**Planning Board Agenda
June 23rd ,2020
7:00pm**

Re: Application for Final Site Plan Approval - Planning Board
Premises: 26 North Myrtle Avenue
Spring Valley, New York 10977

TO: Village of Spring Valley Planning Board
FROM: Michael D. Kauker, PP, AICP
Principal
DATE: May 21, 2020
SUBJECT: **Bruno Neretich South**

To Planning Board:
Re: 26 N. Myrtle Ave
6/19/2020

LAYOUT PLAN FOR
26 N. MYRTLE

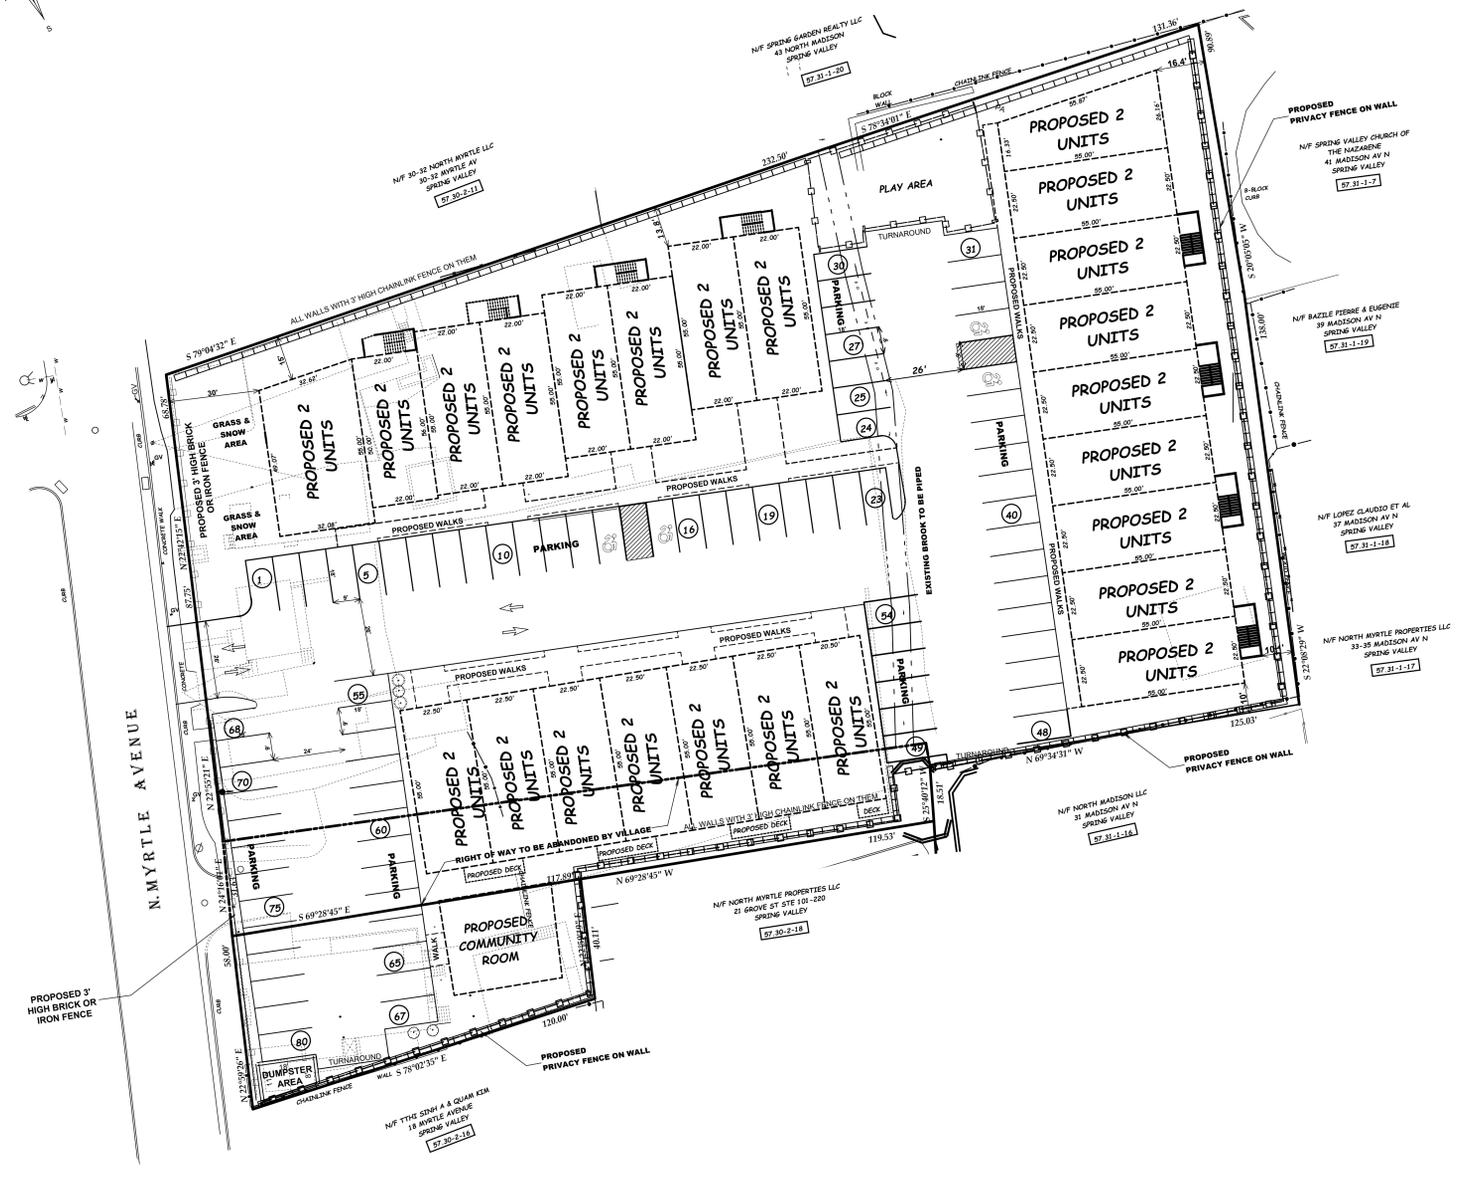
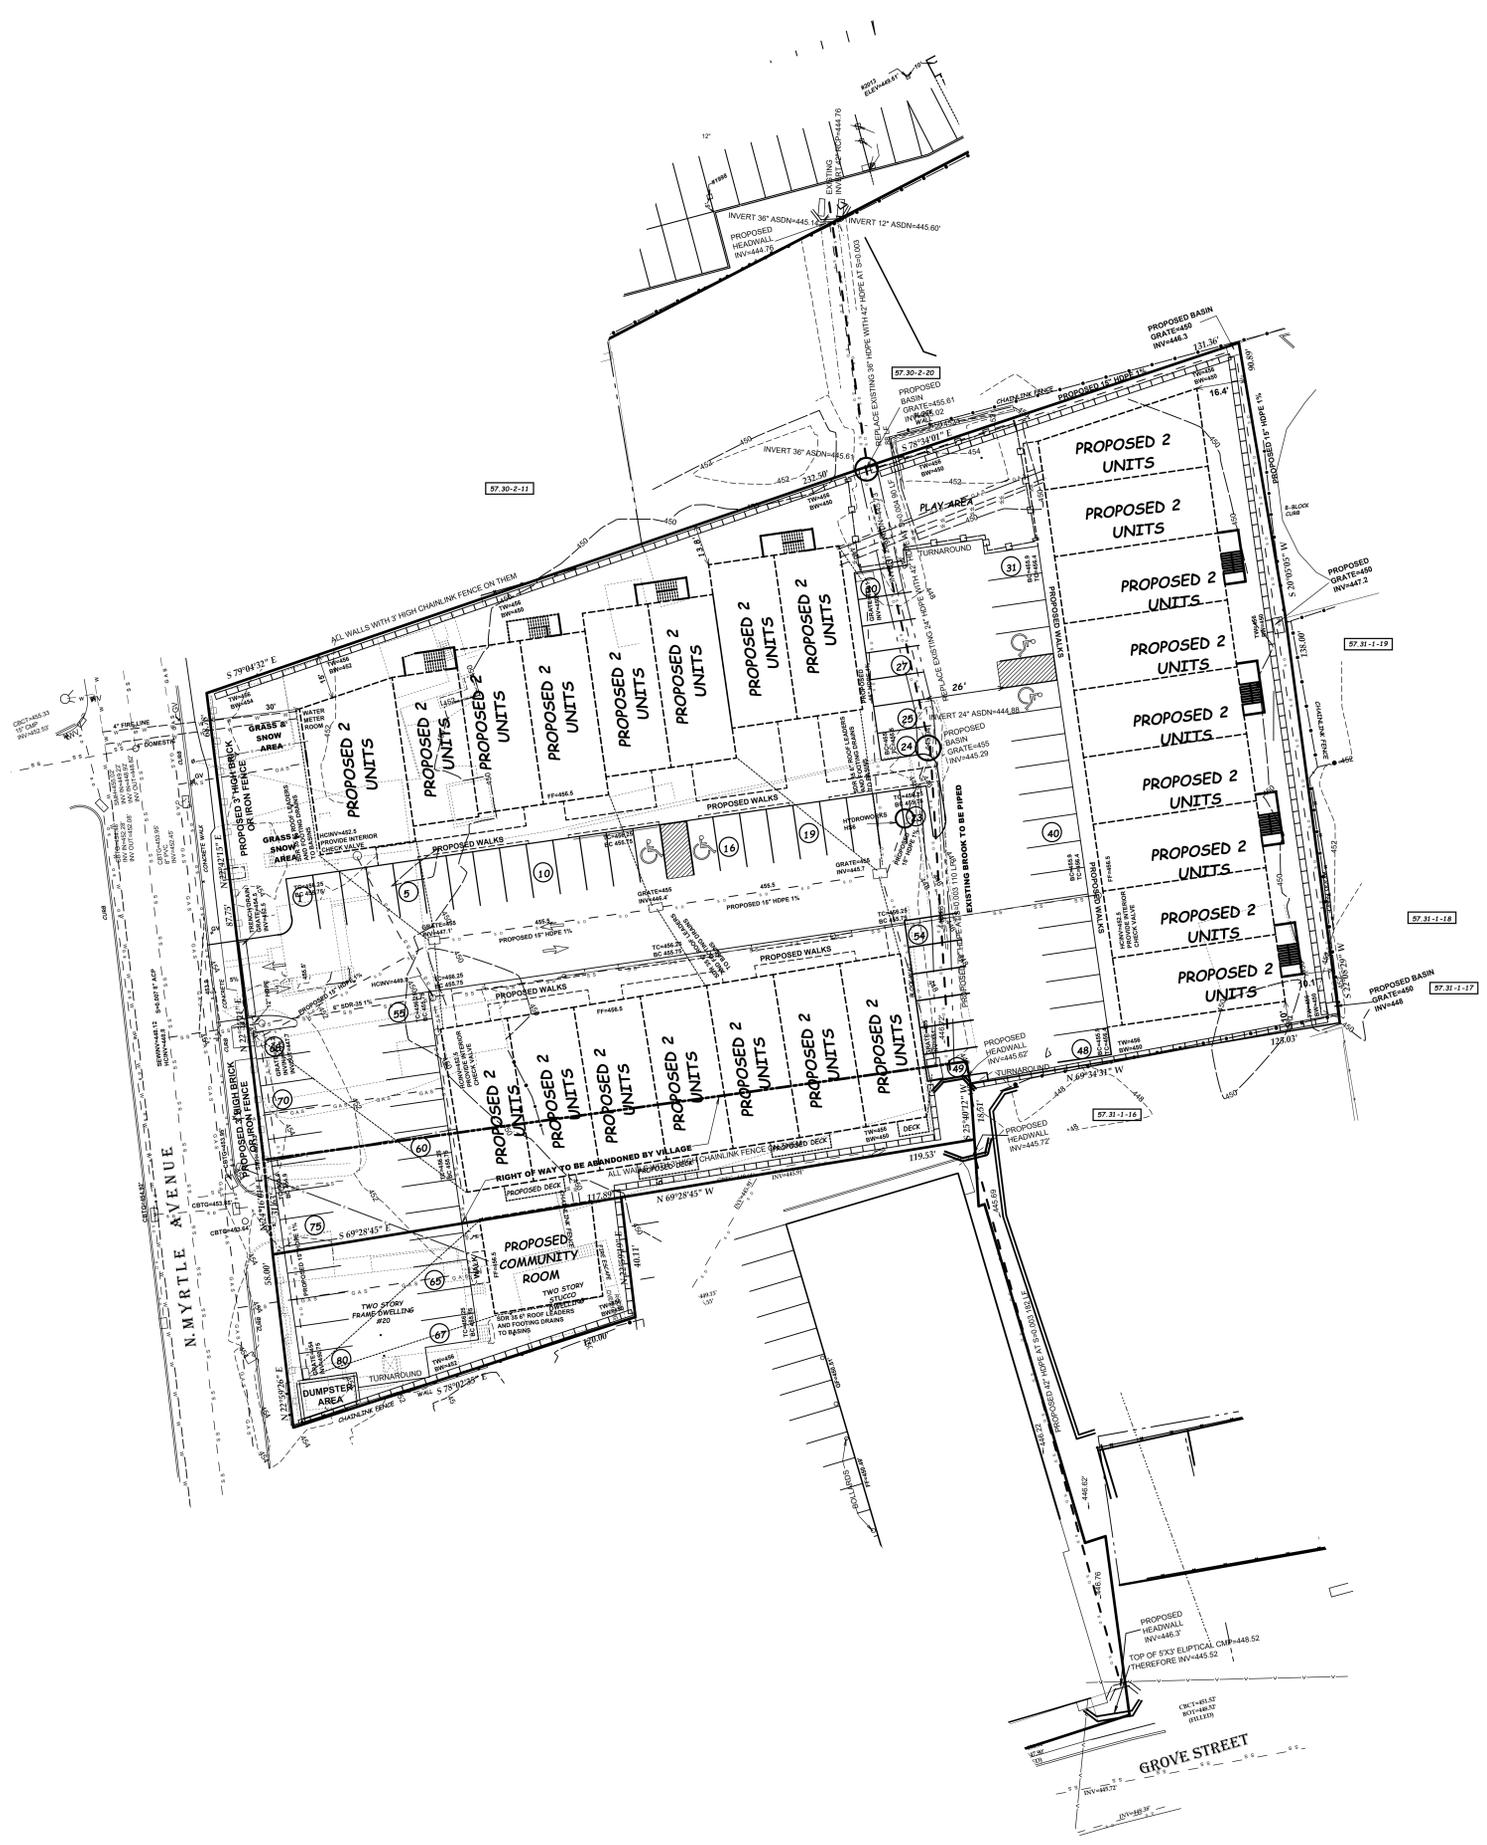
I have reviewed the site plan 26 N. Myrtle Ave dated 2/2/2016 Rev on 5/17/2020. Applicant is providing 26Ft Apparatus Access as well as 120' Ft Hammerhead turn. I am requesting that the curb next to parking spot label 23 be adjusted for rear axle truck Mobility.

- a. Comment #3 – Addressed by the engineer letter attached
 - b. Comment #4 – the application & narrative were provided
 - c. Comment #5 – Map now includes delineation of right of way and abandonment by the Village

- d. Comment #6 – Vicinity Map amended to include entire parcel
 - e. Comment #7 – Parcel 57.30-2-18 has been removed
 - f. Comment #8 – Dumpster has been moved

- g. Comment #9 – Turnaround provided for parking spaces 30, 31, 48, 49, 67, & 80.
 - h. Comment #10 – Snow area relocated.
 - i. Comment #11 – Sidewalks, stairs, decks, & entrances added to the Plan

- j. Comment #12 – pedestrian walkways added to the plan
 - k. Comment #13 – Structures are open decks. All distances requested have been added to the plan

- y. Comment #27 – Applicant will comply
 - z. Comment #28 – Note added to the plan to describe parallel lines (existing brook to be piped)
 - aa. Comment #29 – Applicant will comply
